**STATE ENVIRONMENTAL POLICY ACT
DETERMINATION OF NONSIGNIFICANCE (DNS)
MAPLE ELEMENTARY SCHOOL FIELD IMPROVEMENTS PROJECT**

Maple Elementary School Field Improvements Project

**Maple Elementary School
Field Improvements
FINAL SEPA Checklist**

APPENDIX B
RESPONSE TO PUBLIC COMMENTS

Figure 2. Site Plan

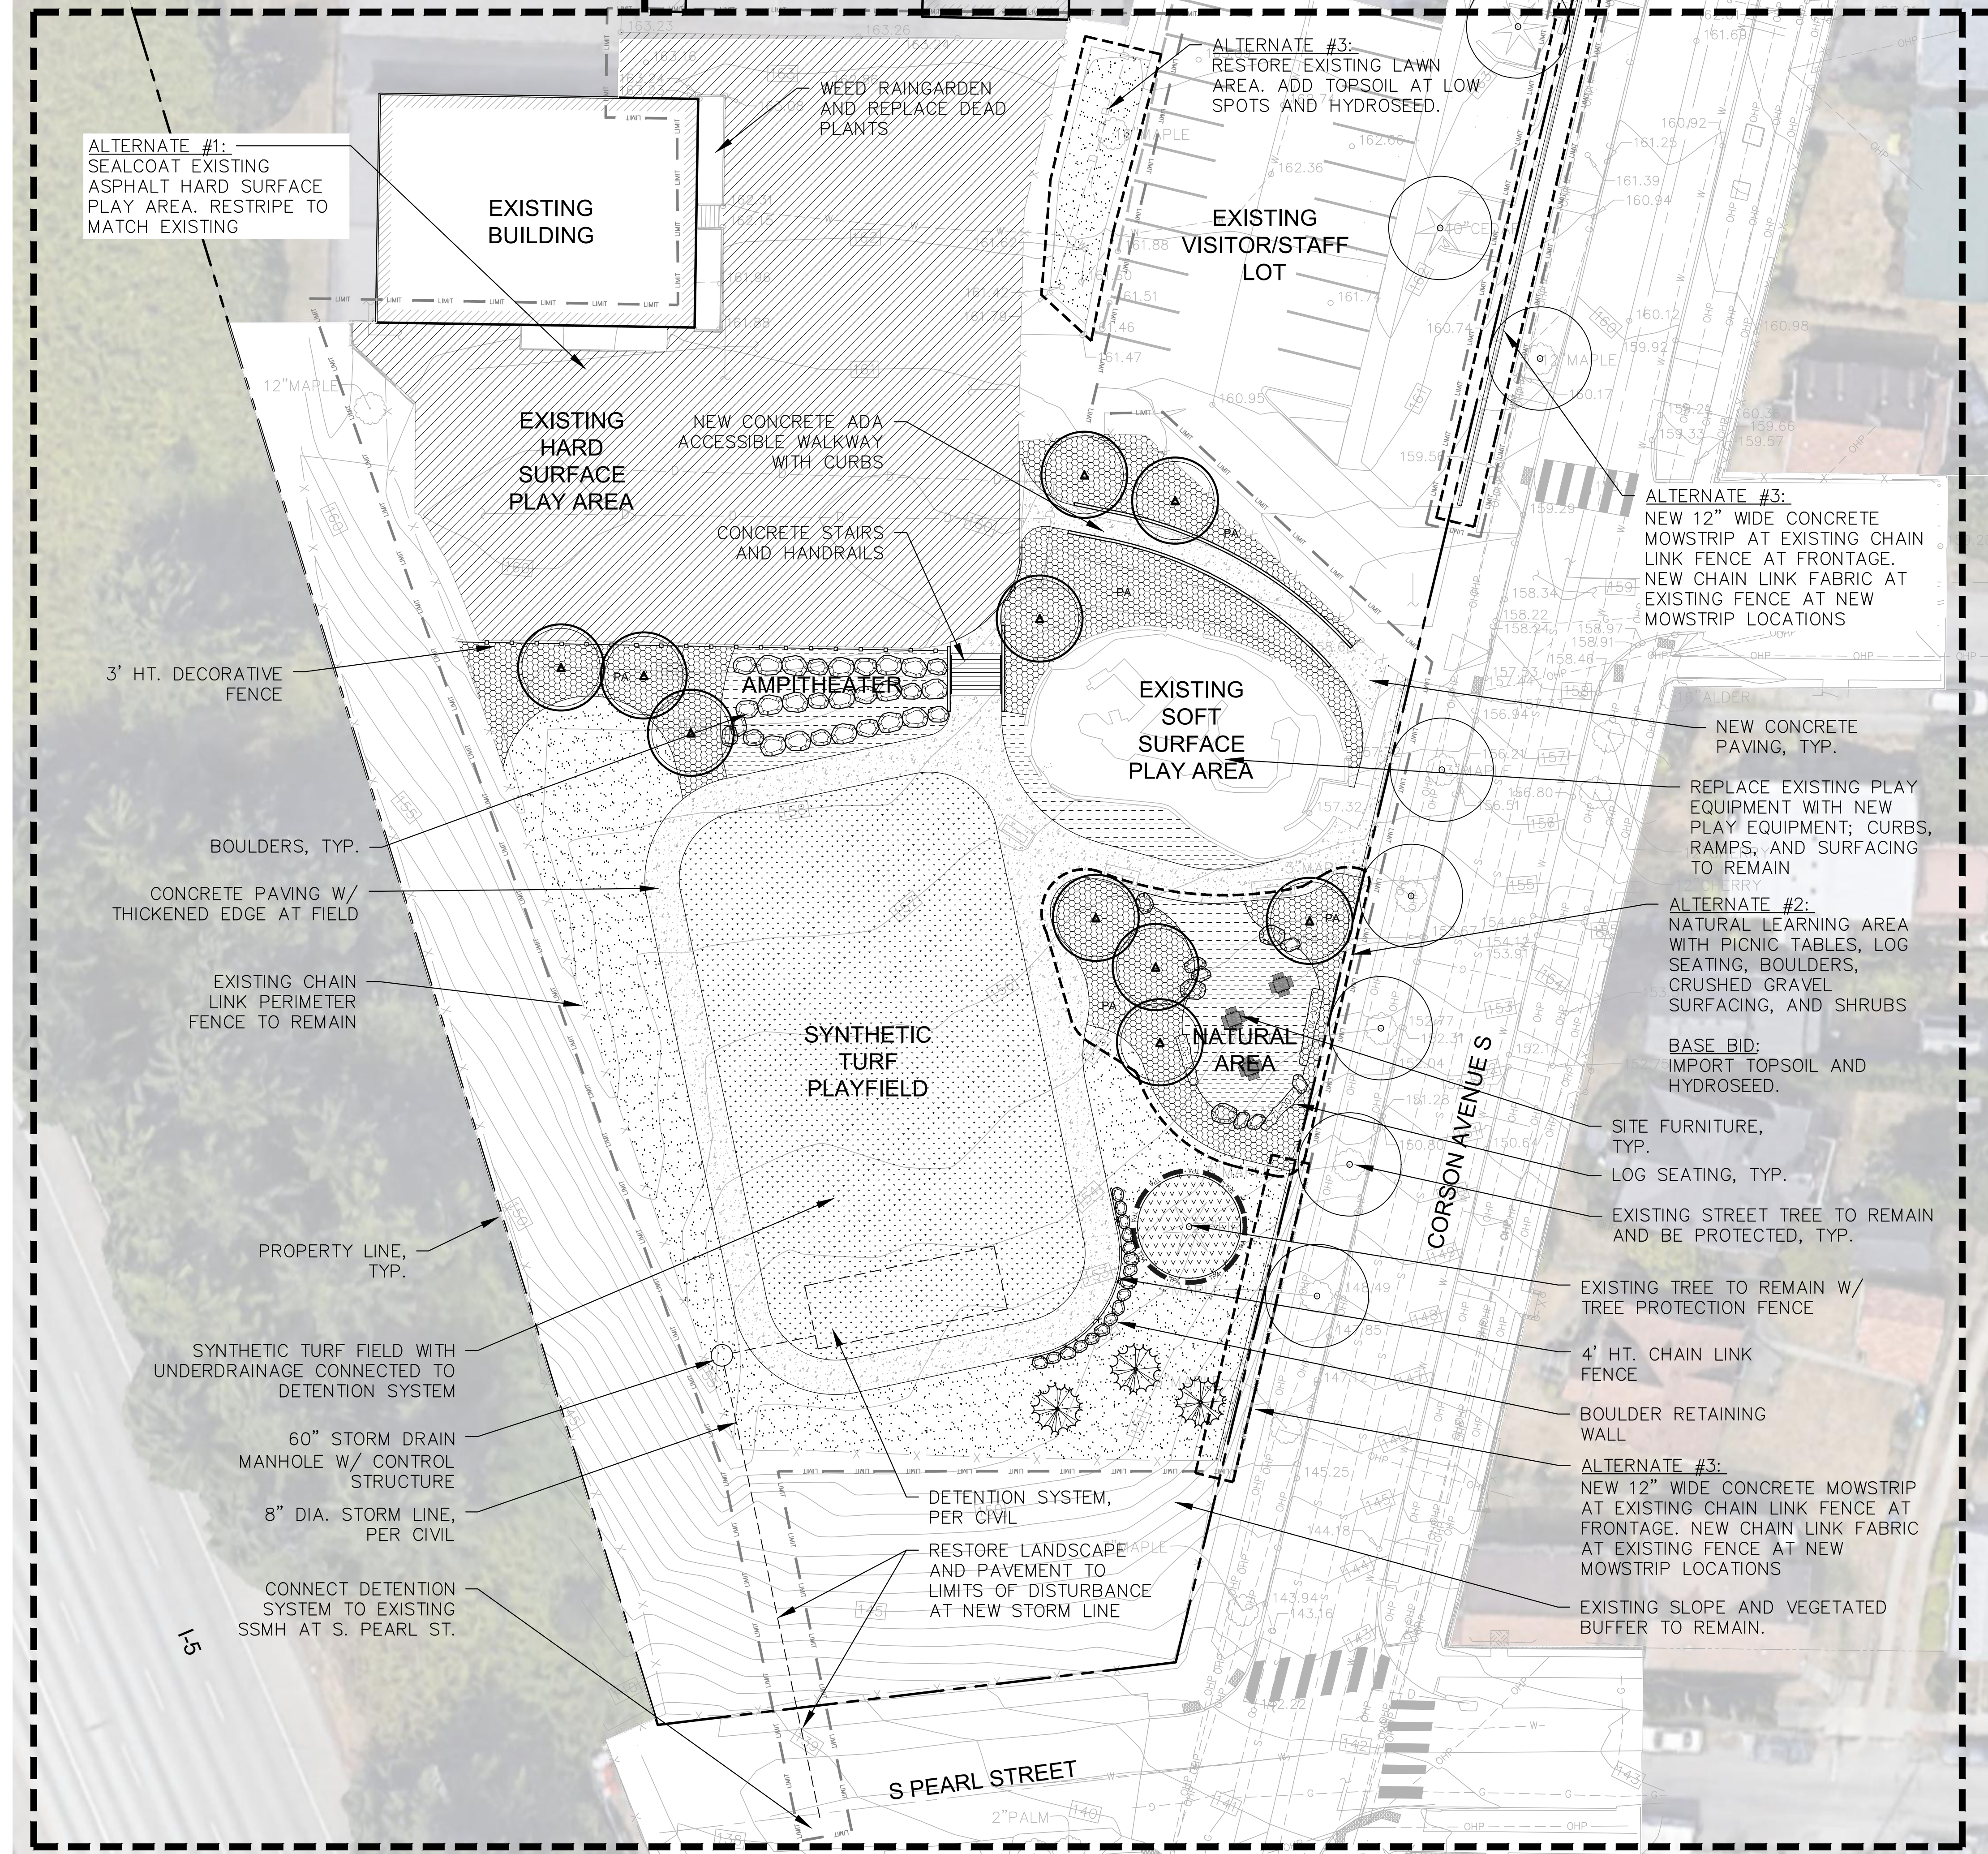
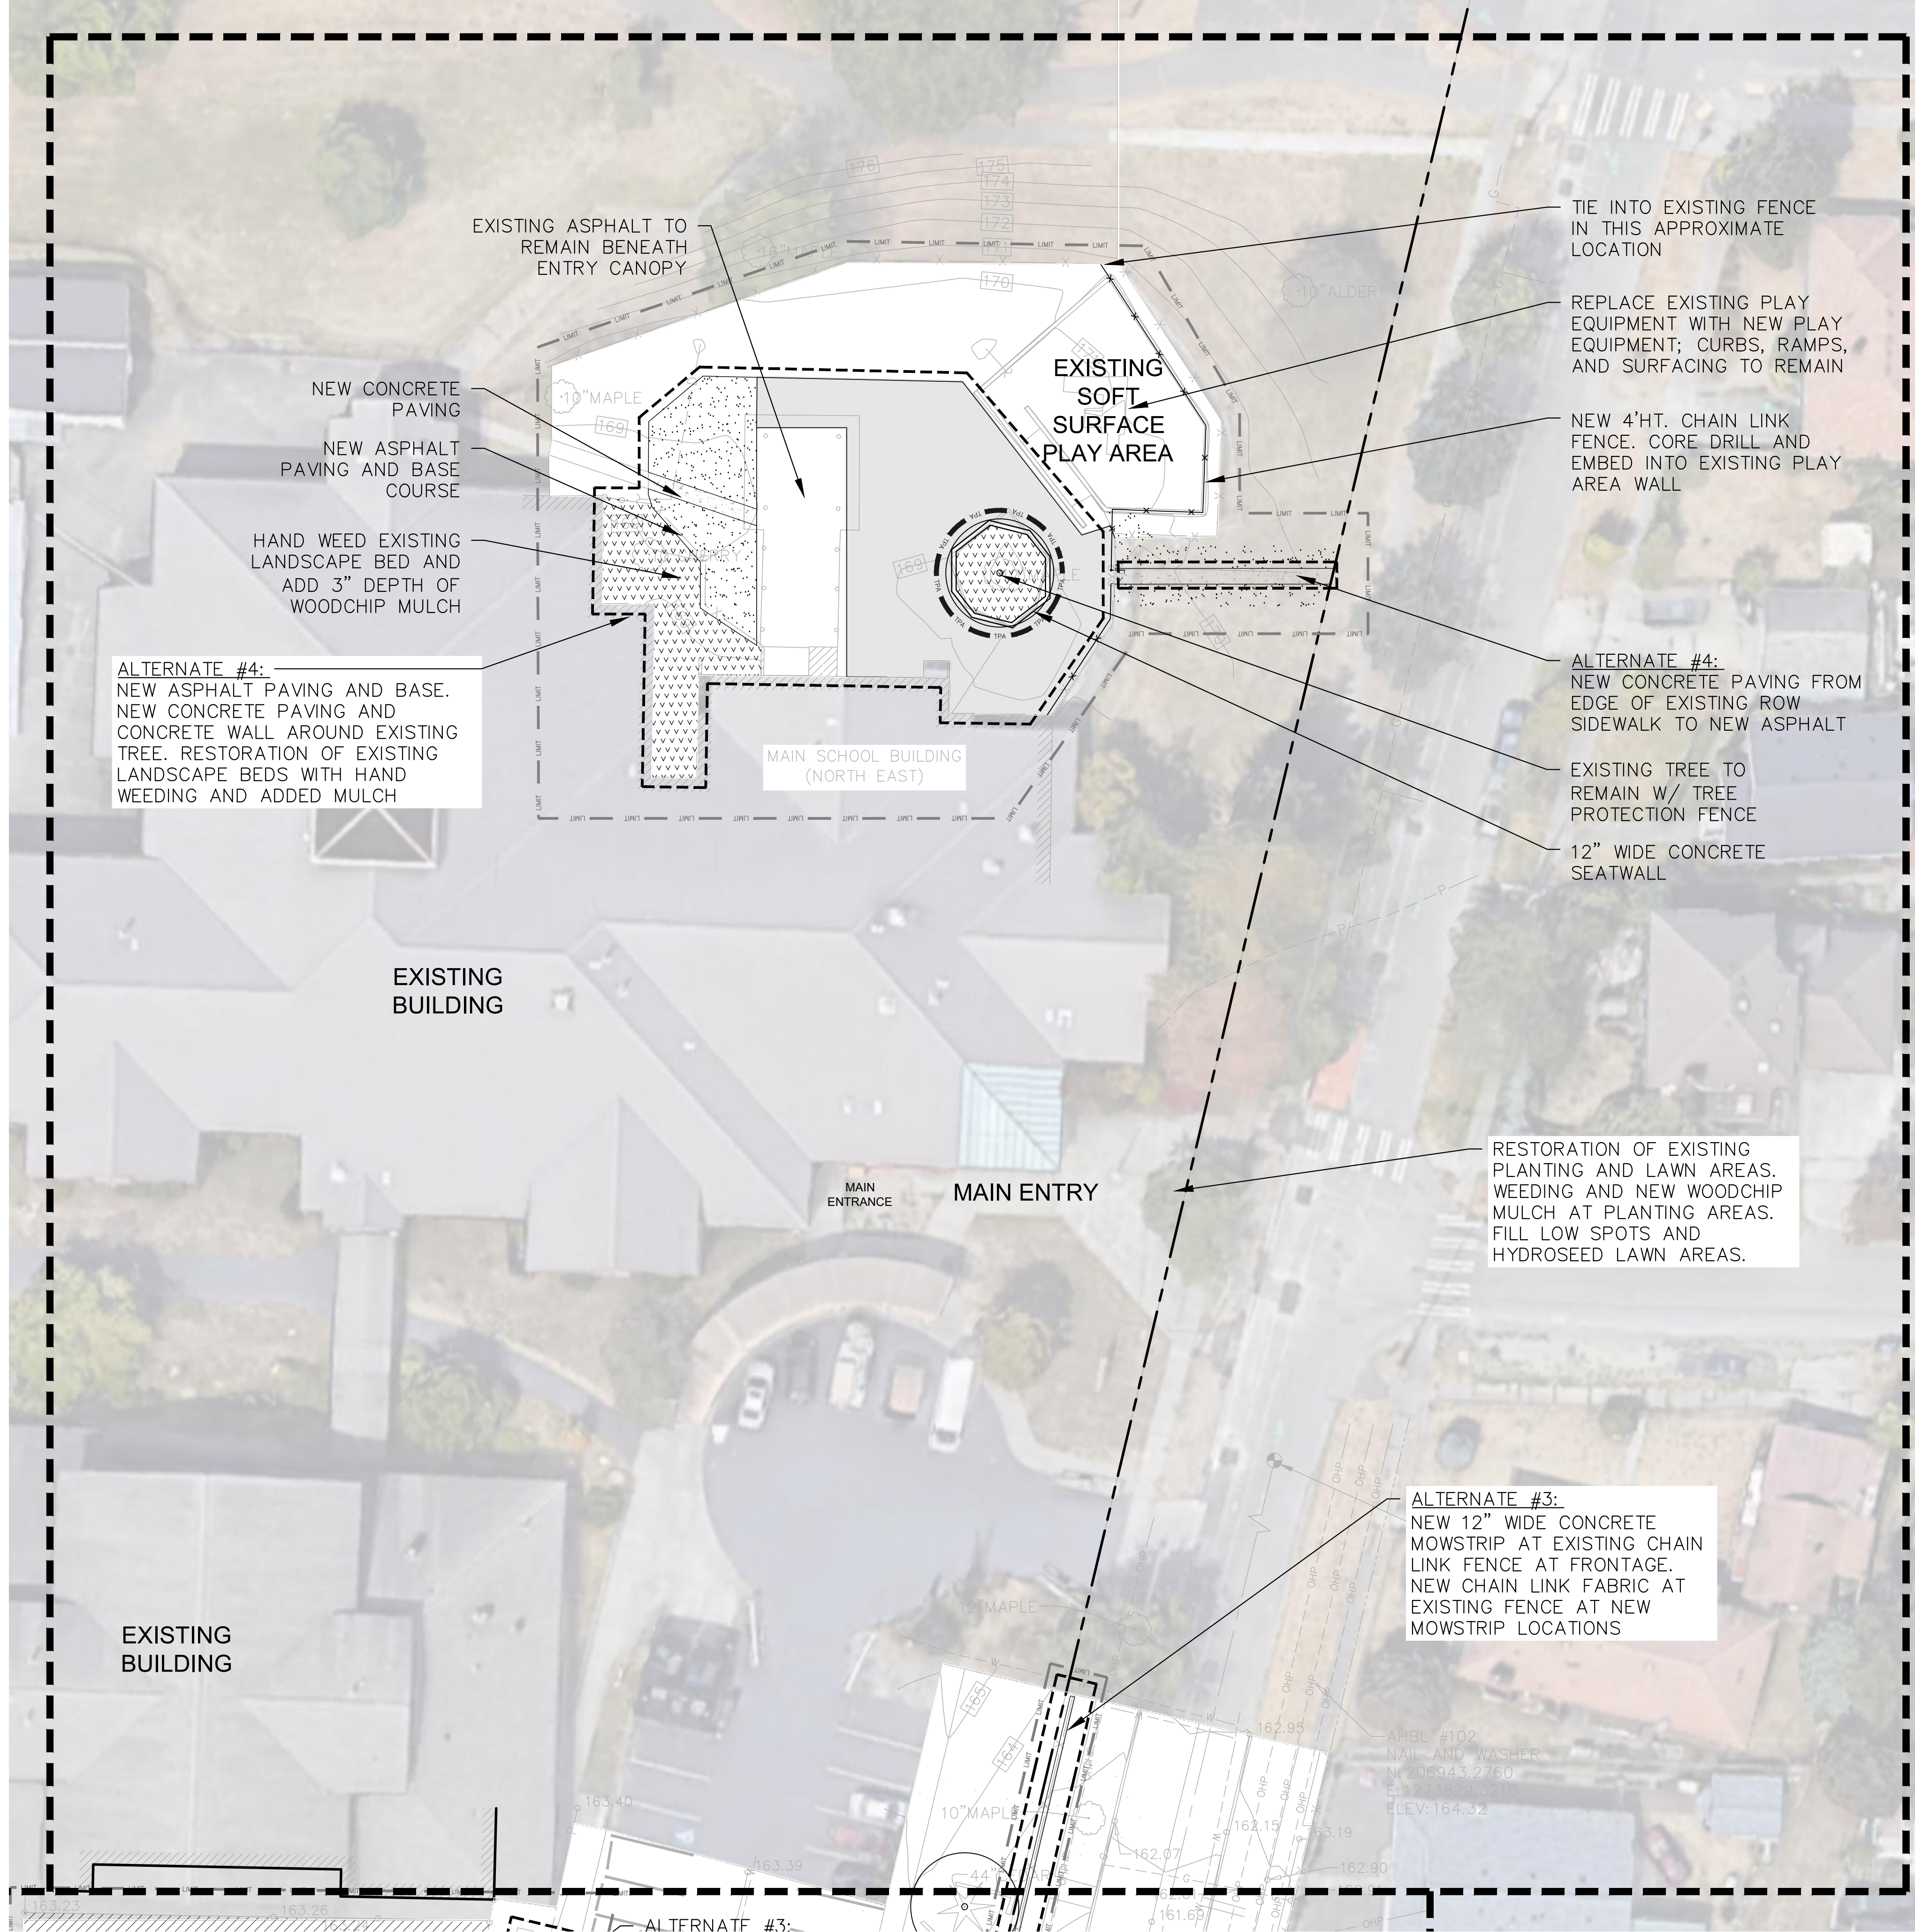
- 6. Field Drainage.** As it current(ly) stands, Maple Elementary frequently has to close the field in the winter due to excessive rain and the field turning into a pit of mud. It's clear based on the plan that the district will not be installing turf, which would solve this problem. Are there intentional plans for drainage so that the field will be usable year-round. [Commenter 2]

Response: The proposal for the site is to replace the existing lawn with synthetic turf with a sand underdrain and cork infill. The site plan attached to the Final SEPA checklist shows a synthetic turf play field with under drainage. The purpose of installing a synthetic turf field is to allow year-round access and eliminate issues due to rain.
